**Champlain Hudson Power Express ("CHPE")
Environmental Management & Construction Plan
Notice of Major Change**

Project: Champlain Hudson Power Express

Segment: 12

Notice Number: 054

PERMIT DRAWING NO.
N/A
DRAWING NO.
C-108

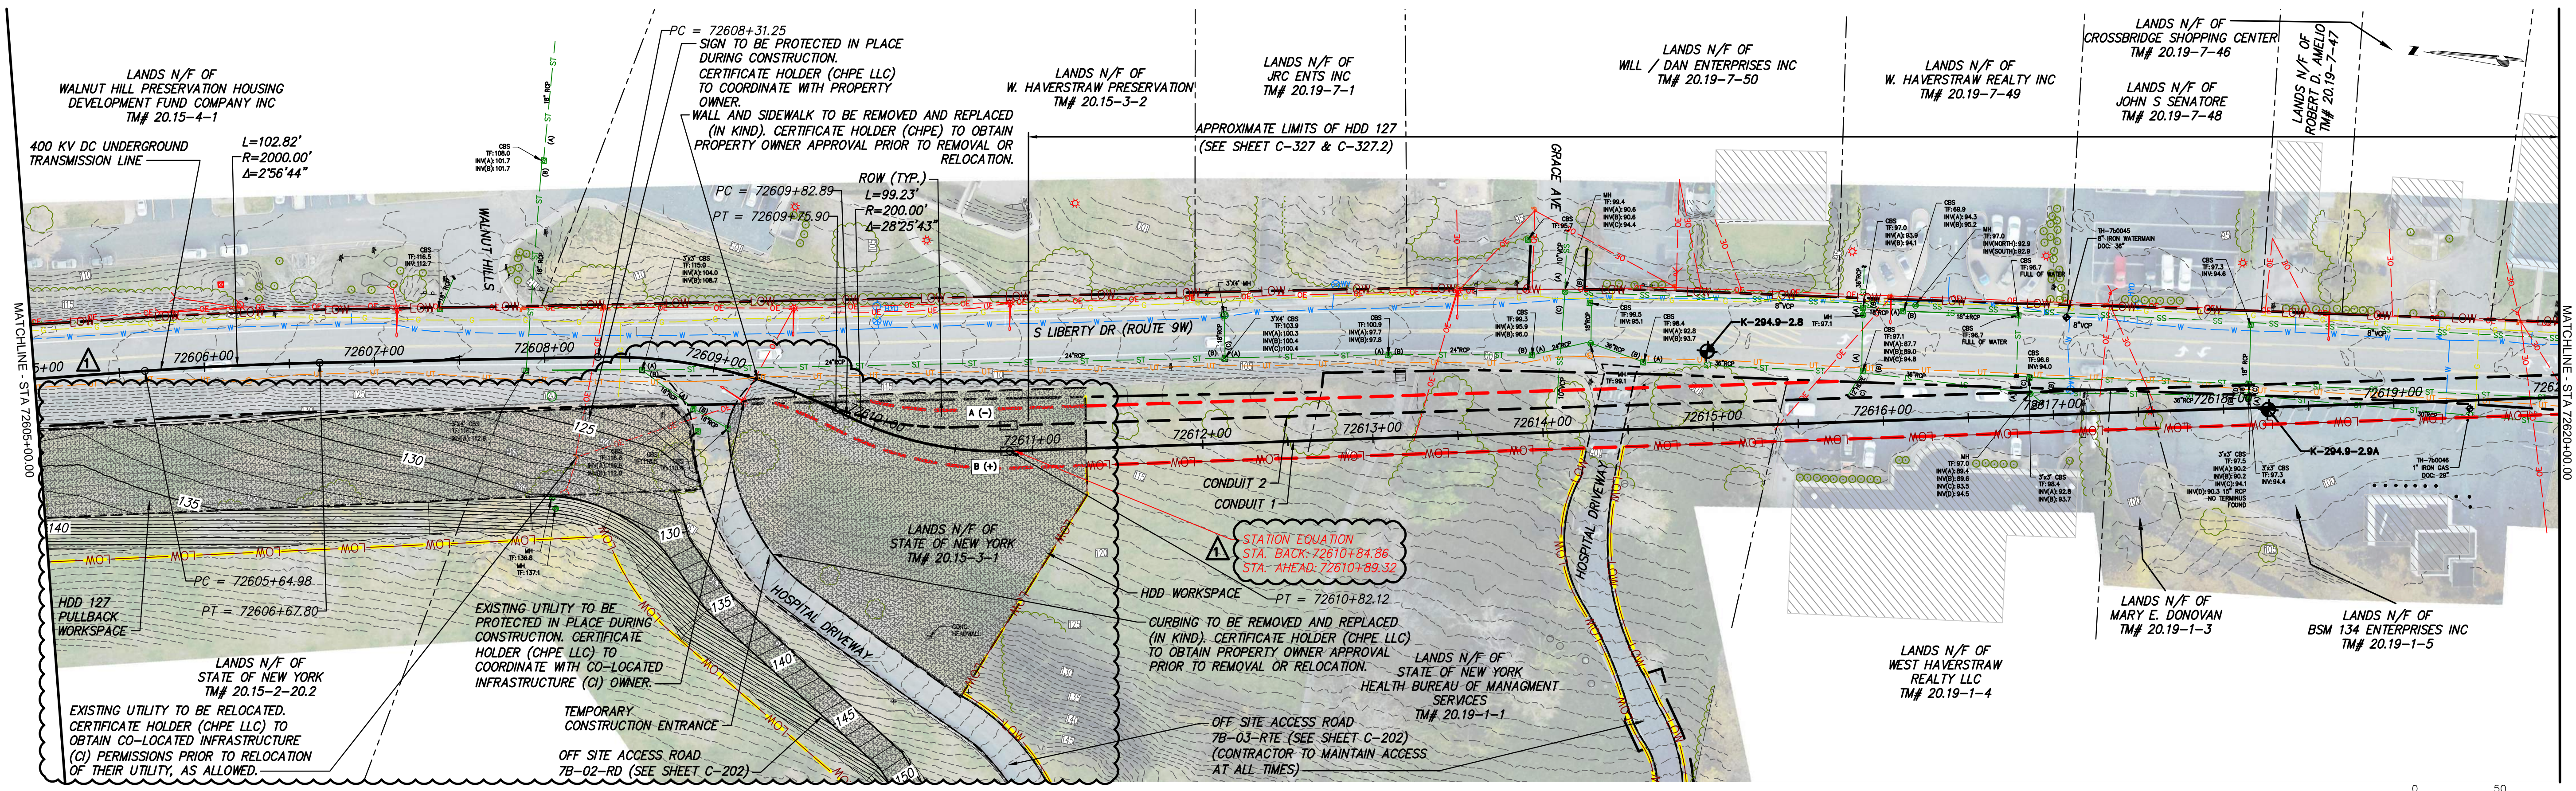
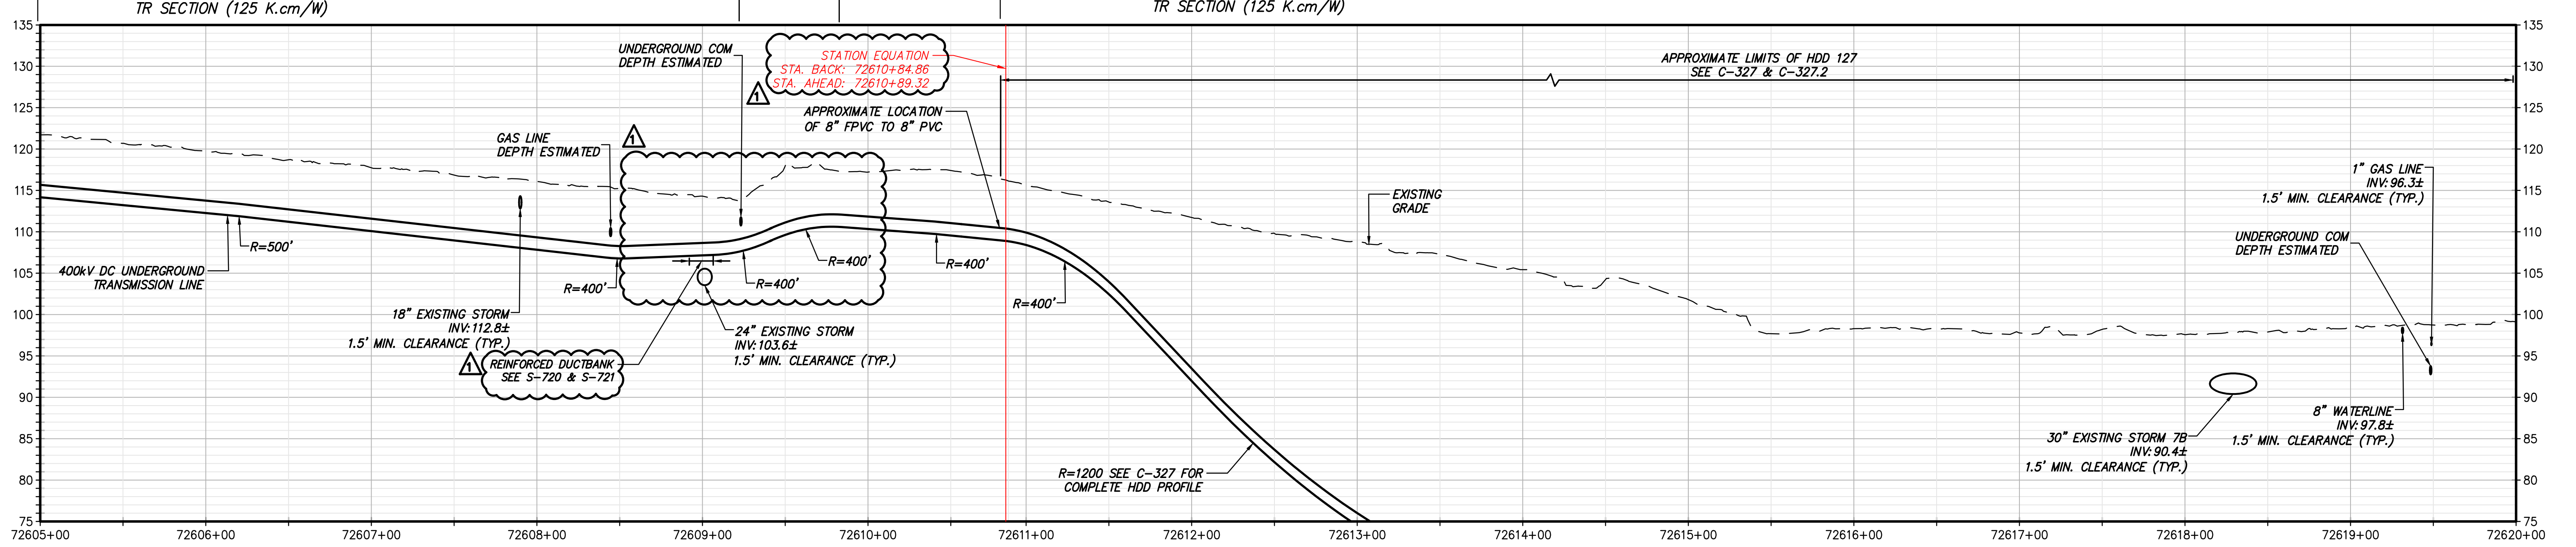
- C. Elimination of Jack & Bore:** To avoid disturbing a previously assumed historic wall, jack & bore method was proposed to install the CHPE conduits under the retaining wall at approx., sta. 72609+25 in front of Helen Hayes Hospital. After further investigations, the New York State Parks, Recreation & Historic Preservation office indicated that the existing wall of Helen Hayes Hospital along Rt 9W is not eligible for National Register as a historic structure due to recent modifications and demolition of a historic structures in the vicinity. To minimize potential disruptions caused by the jack and bore operation both to traffic and the hospital, CHPE conduits will be installed using trenching method through the retaining wall. The wall will be restored in kind. Concurrence from the office of the Helen Hayes Hospital was received via email dated October 6, 2023 for this change.

This change also necessitated a minor adjustment to the horizontal alignment that avoided the trench encroaching multiple travel lanes of Route 9W between Sta. 72607+00 and 72608+50. As a result, temporary pavement proposed to maintain traffic on the north bound lane of Rt 9W will no longer be required as reflected on sheet O-708.

- Consistent with NYSDEP request to install reinforced ductbank over all DEP regulated stream crossings to facilitate future improvement at those facilities, similar note has been added to all drainage crossings throughout this segment (Shts. C-101, C-103, C-104, C-107, C-108, & C-115).

- Gravel hatching has been added to the temporary access roads and HDD work area (Shts. C-107, C-108 & C-202)
- Supplementary topographical survey information has been incorporated to the plans (Shts. C-102 & C-104).

This change would also require updating Deviation Zone Excursion # S12-6 of Table 1 of EM&CP "Appendix E Justification for Deviation Zone Excursions in Segment 12" and its Justification below:

Excursion	Parcel ID	Location (Approximate – see Drawings for Details)				Justification for Revision	Environmental Impact Reviewed
		Sheet	Mile Point	Station Start	Station End		
S12-6	20.15-3-1 20.19-1-1 20.19-1-4 20.19-1-3	C-108	2.7-2.9	72609+00	72619+00	Trench Work Area; Avoidance of subsurface utilities	Cultural Resources; ESA 1; Wetlands; Terrestrial Ecology

PERMIT DRAWING NO. N/A
DRAWING NO. C-109

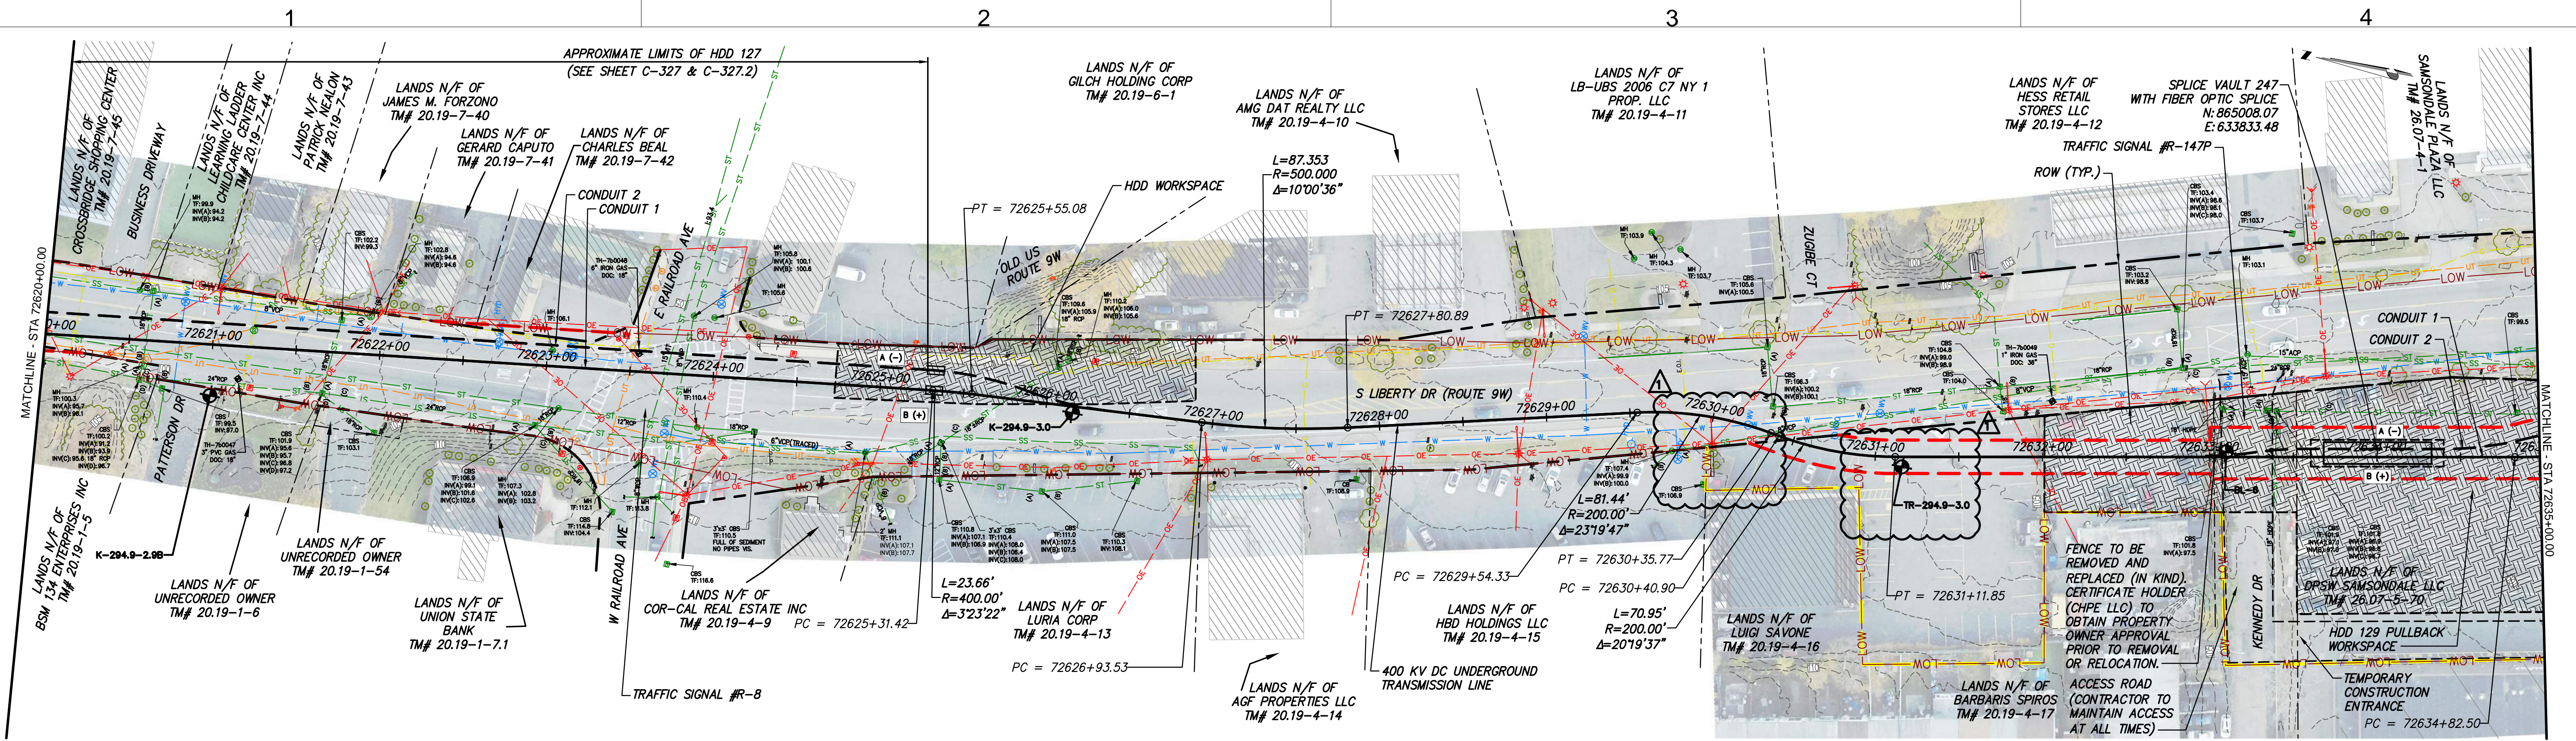
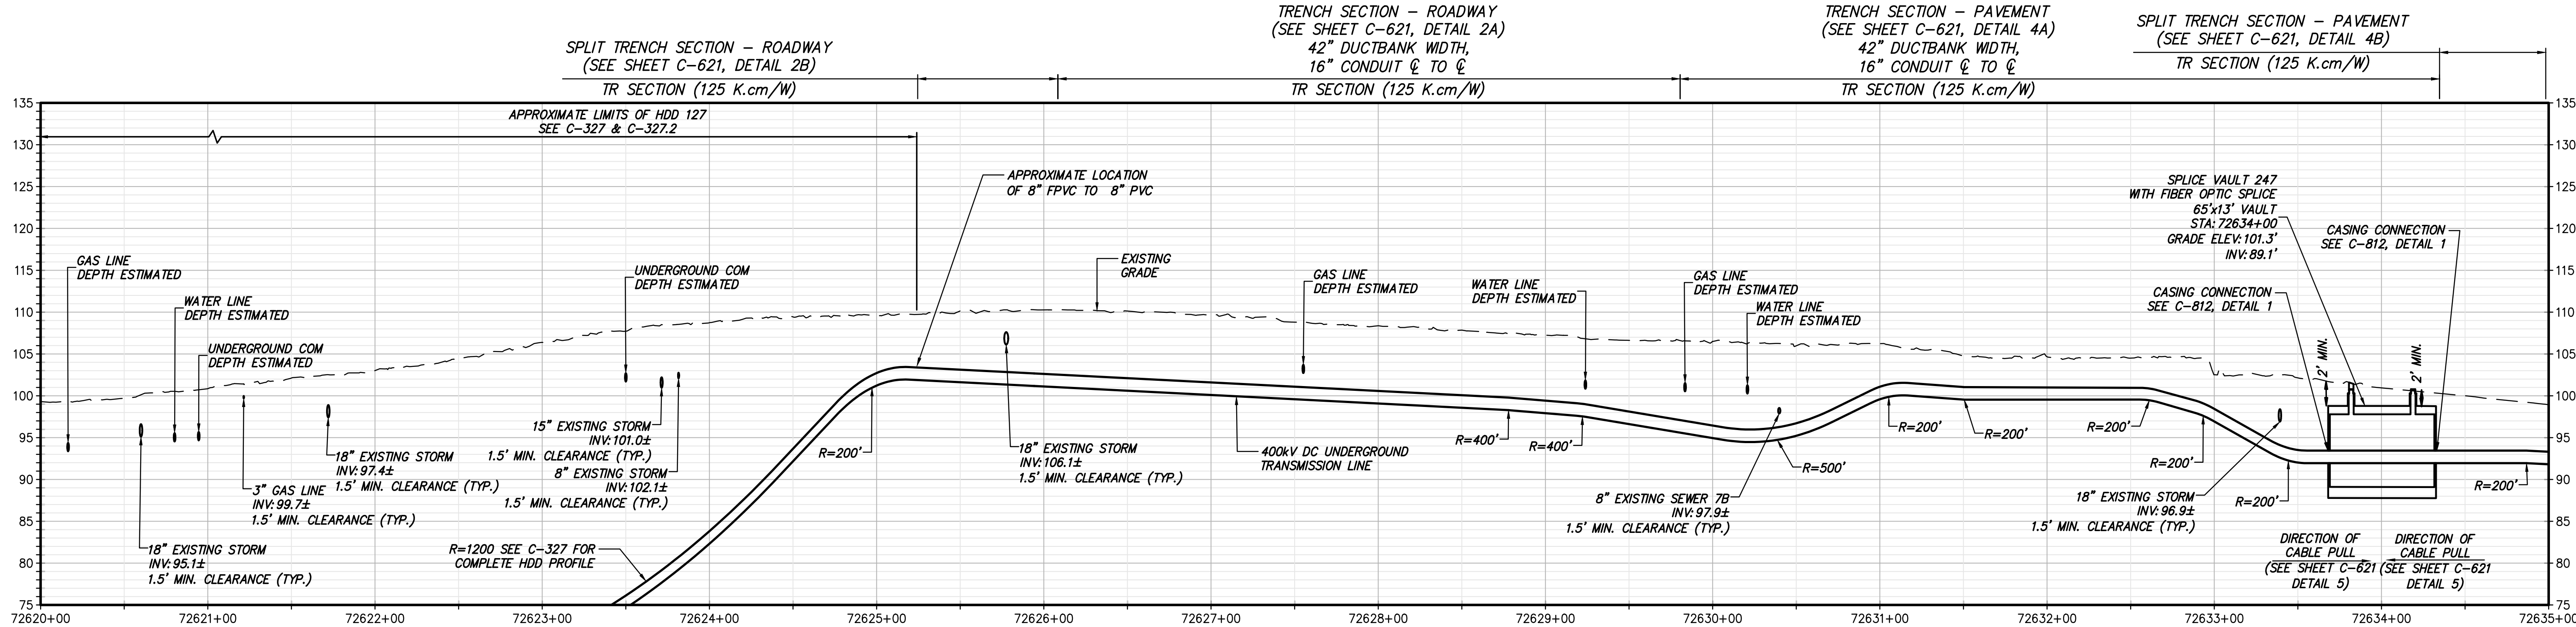
- D. Changes to Limit of Work (LOW):** To optimize the Facility alignment, small limit of work (LOW) encroachments into two separate properties were eliminated. The properties from which the LOW easements were removed include Town of Stony Point TM# 20.06-1-37.1 on sheet C-104 (~80 sf) and HBD Holding LLC TM# 20.19-4-15 on plan sheet C-109 (~100 sf). The LOW line within the adjacent property of Luigi Savone TM # 20.19-4-16 on sheet C-109 (~465 sf) was adjusted to optimize use of available space for construction.

- Notes from Orange and Rockland (Gas & Electric) added to sheet G-004.
- Location of additional soil borings have been added (Shts. C-101, C-103, C-106, C-107, C-109, C-112, C-118, C-124, & C-125).
